171518 CDAA

KU-RING-GAI HIGH SCHOOL

Response to Initial Assessment

This letter aims to respond to civil engineering matters raised within Ku-ring-gai Council's Initial Assessment of the Development Application for Ku-ring-gai High School (DA0586/18). The matters raised relate to the stormwater point of discharge and to the provision of a rainwater tank.

Figure 1: MUSIC Modelling Layout

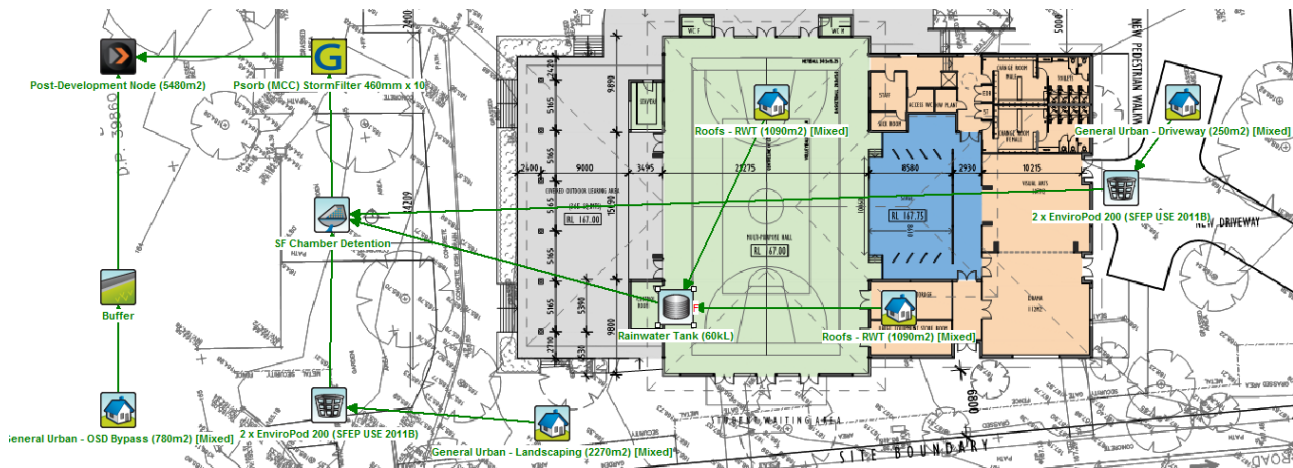
Refer to **Figure 1** for a schematic layout of the MUSIC model, **Figure 2** for the results of the model, and **Figure 3** for the rainwater tank node water balance. Revised stormwater design drawings are included as Appendix B.

The original design included a combined rainwater and onsite stormwater detention (OSD) tank. Following the request to provide a rainwater reuse system in lieu of an OSD tank, a water balance calculation has been undertaken to determine the appropriate size of rainwater tank.

We have been advised by the hydraulic engineer that rainwater re-use will be for toilet flushing within the site. As the hall contains 11 toilet facilities, and assuming an average daily demand of 0.1kL/day/toilet, the re-use demand on the tank is equal to 1.1kL/day. Rainwater re-use has been modelled within the Model for Urban Stormwater Improvement Conceptualisation (MUSIC) with the proposed rainwater tank. It was determined that the proposed effective volume of 60kL would allow for 99.29% of the re-use demand to be met.

In terms of water quality measures, the development also proposes Stormwater 360's Enviropod pit inserts in 4 surface inlet pits and 10 460mm Stormfilter cartridges downstream of the rainwater tank.

TURRAMURRA
 HIGH SCHOOL
 HYDRAULIC SERVICES
 SITE PLAN
 STORMWATER DRAINAGE

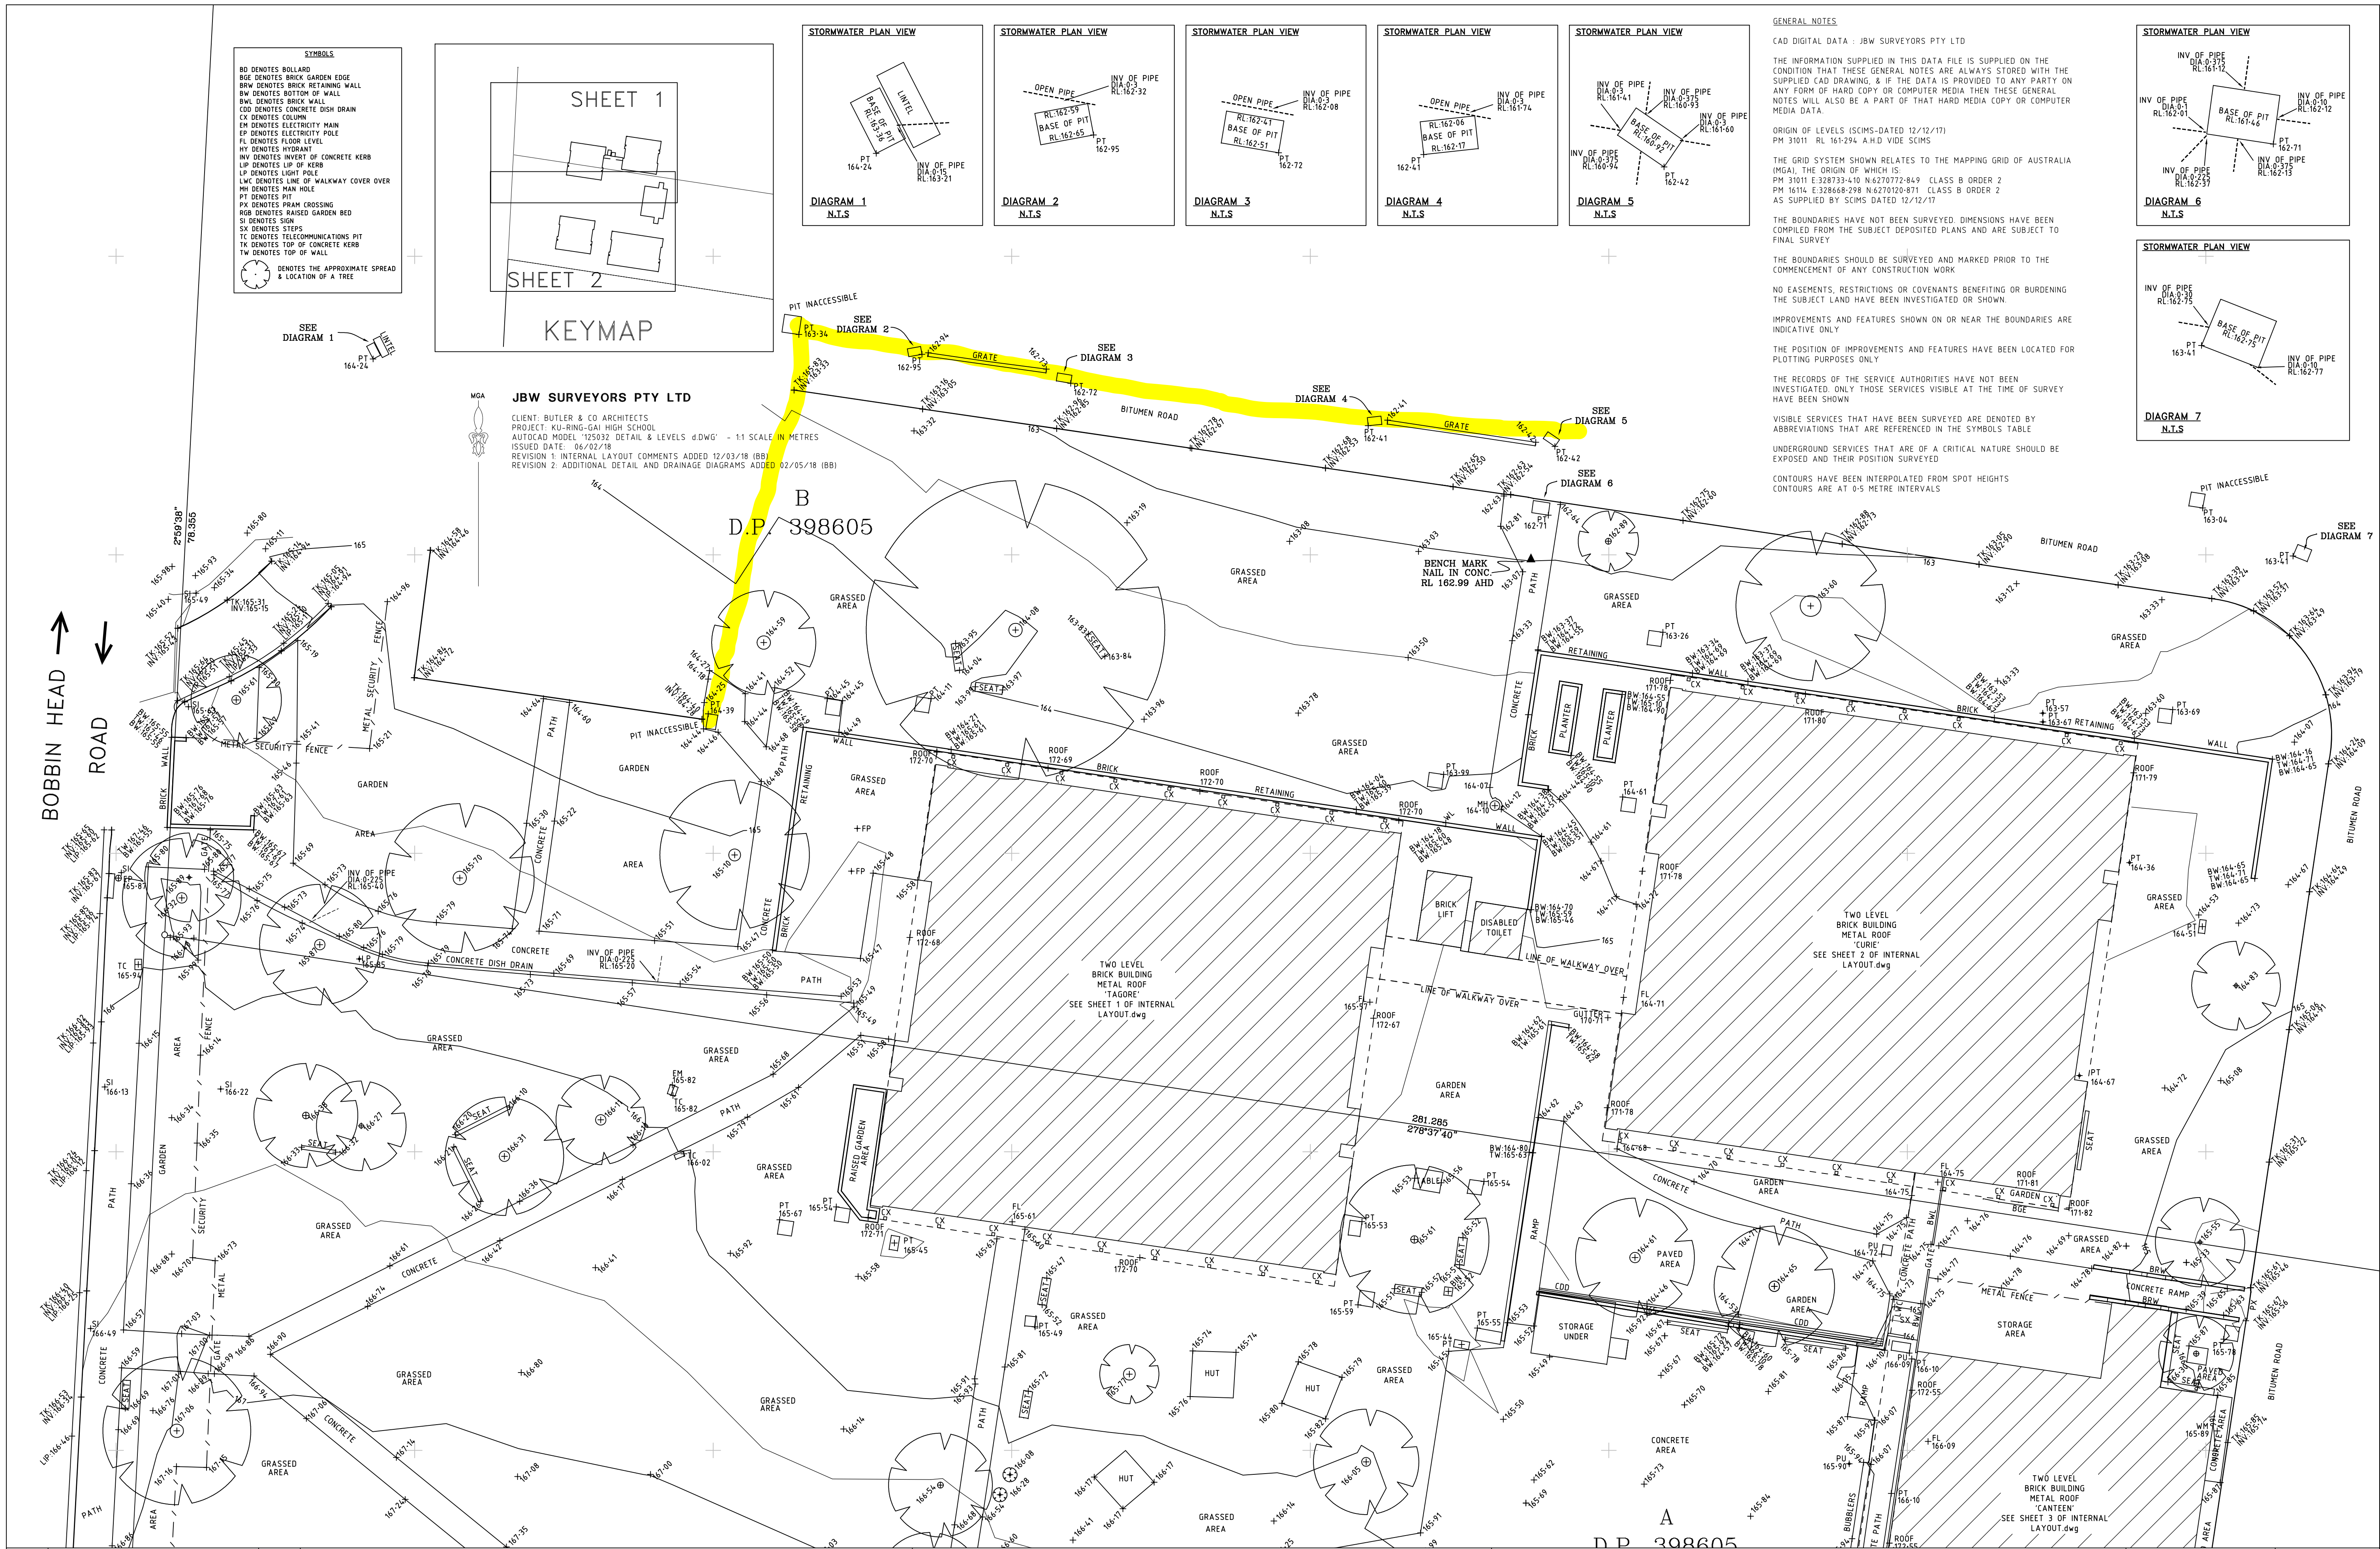
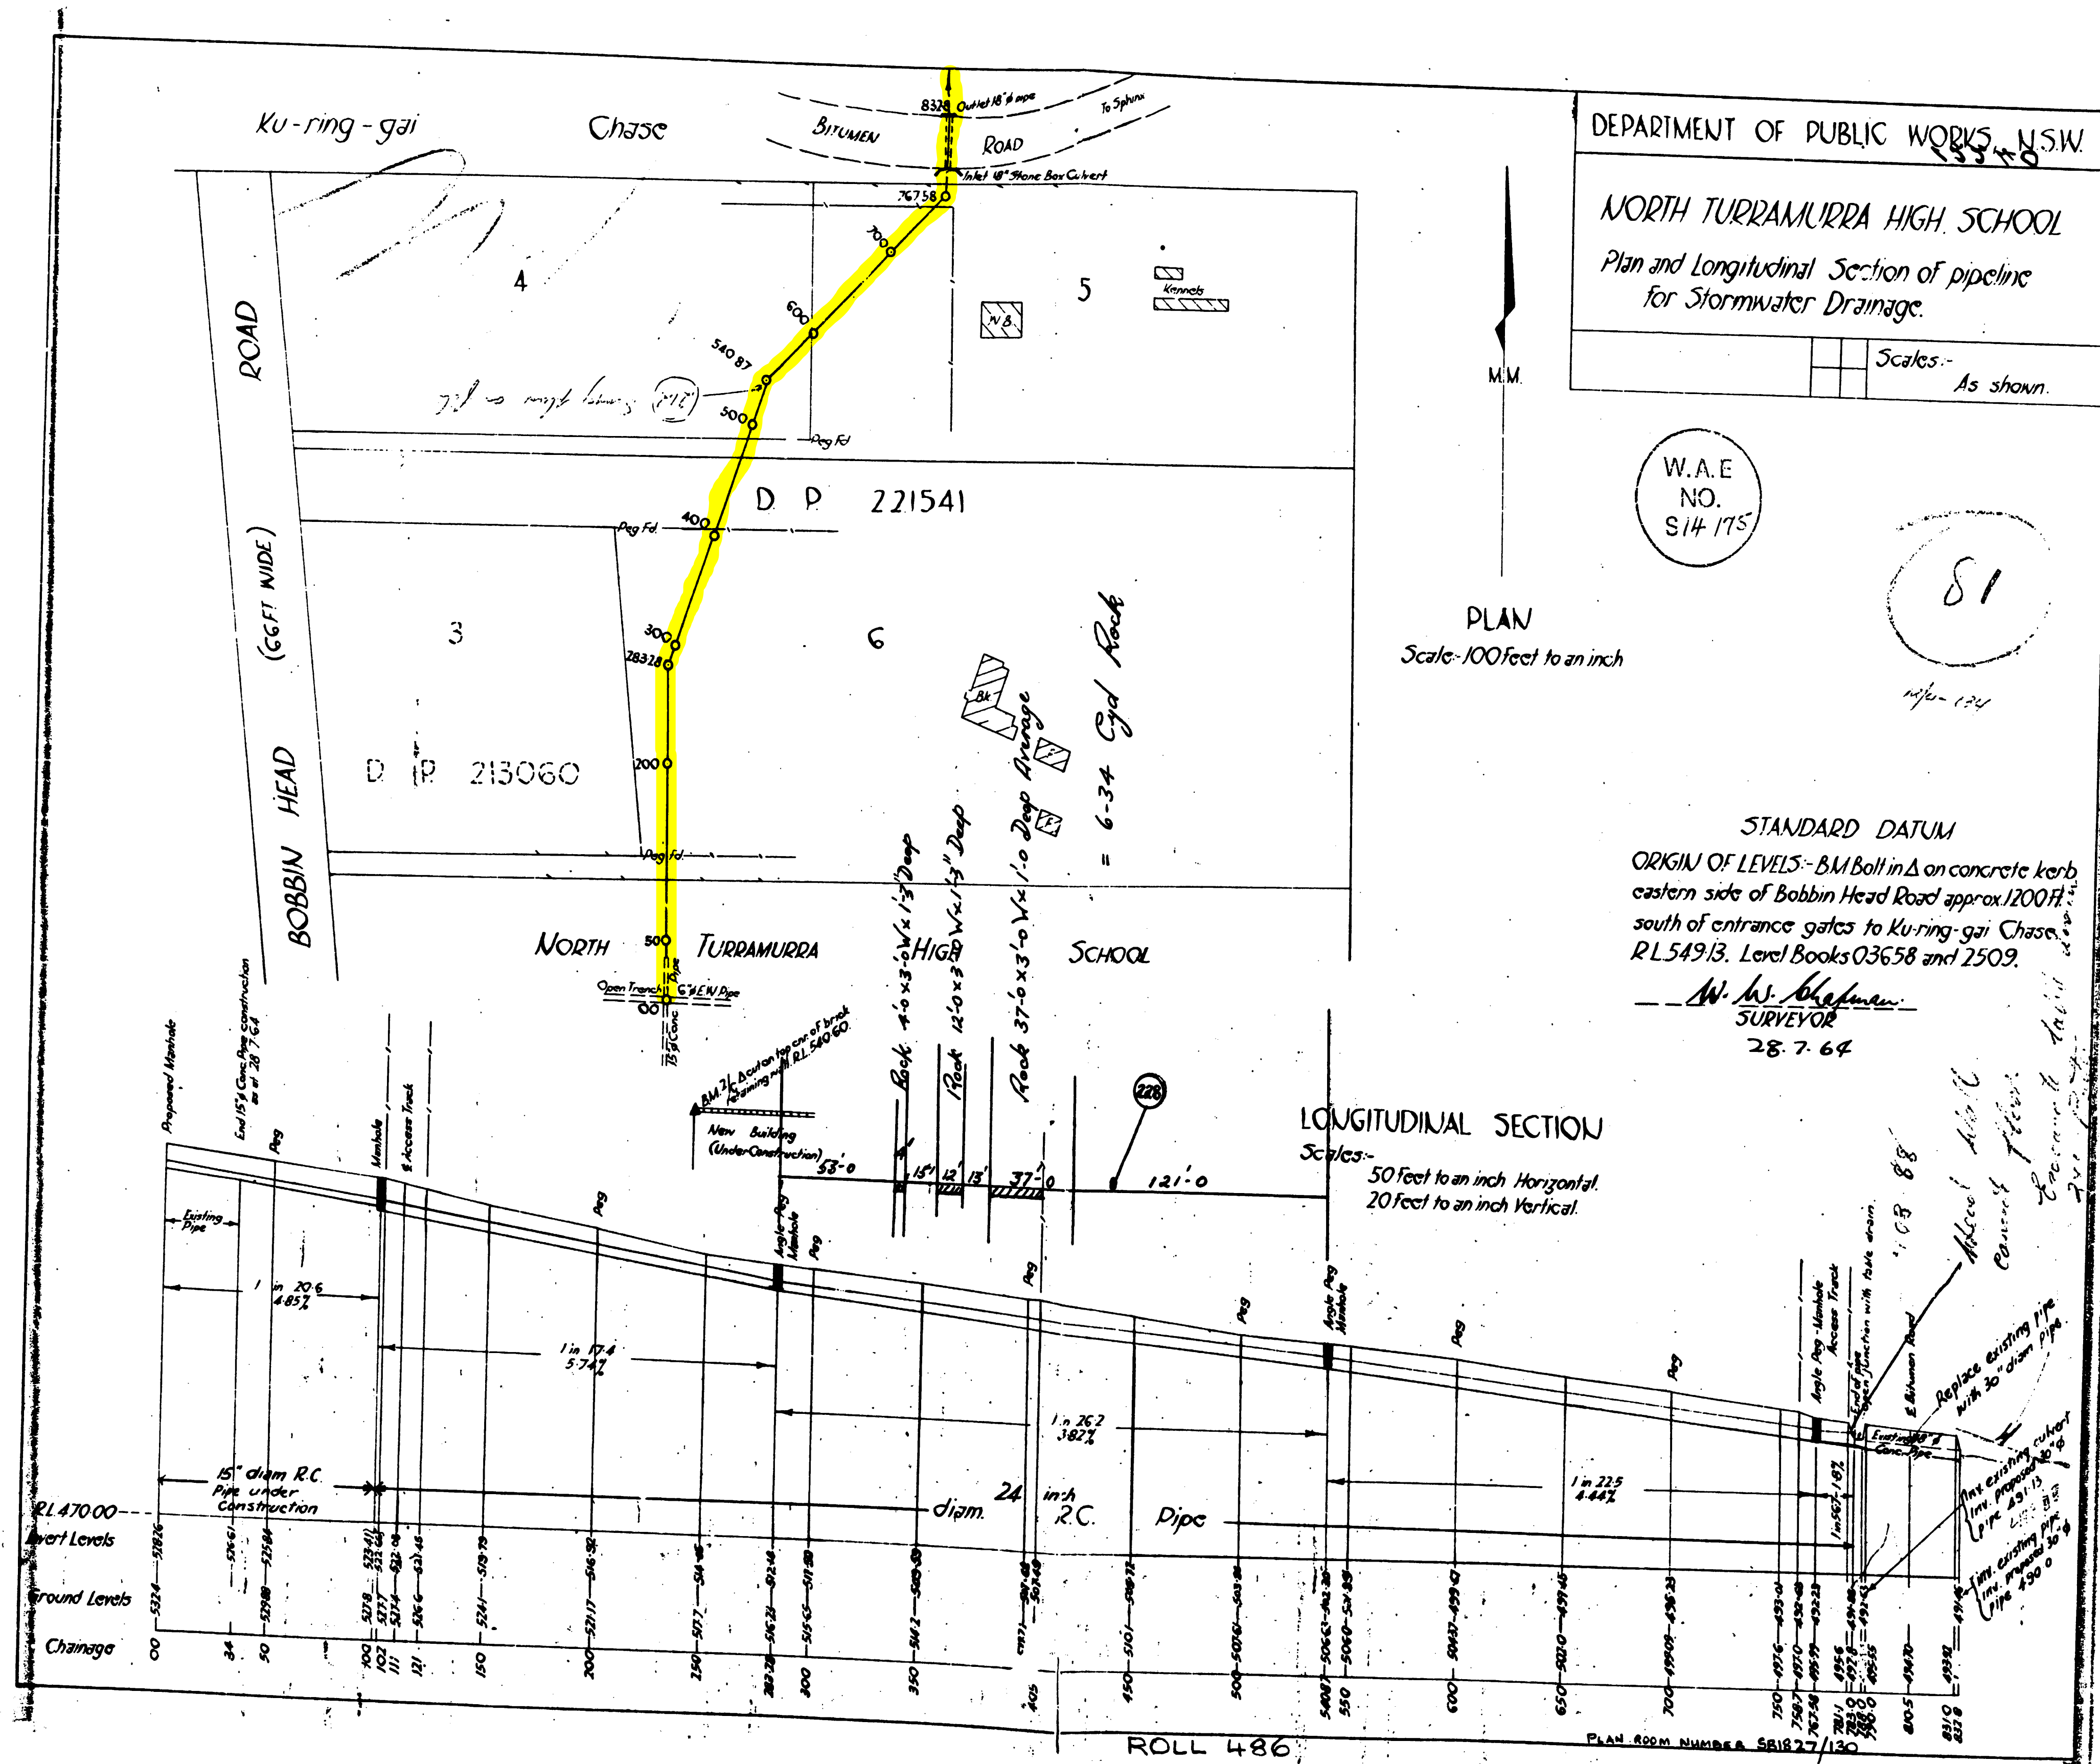
Through site investigation, review of historical documents and the survey conducted for the development, stormwater from the site is conveyed to the east and then north through to Ku-ring-gai Chase National Park via a 600mm diameter pipe. As a result, the point of discharge of the site would be to the existing outlet to the National Park. Refer to the attached historical drawings and survey in Appendix A showing the stormwater drainage network.
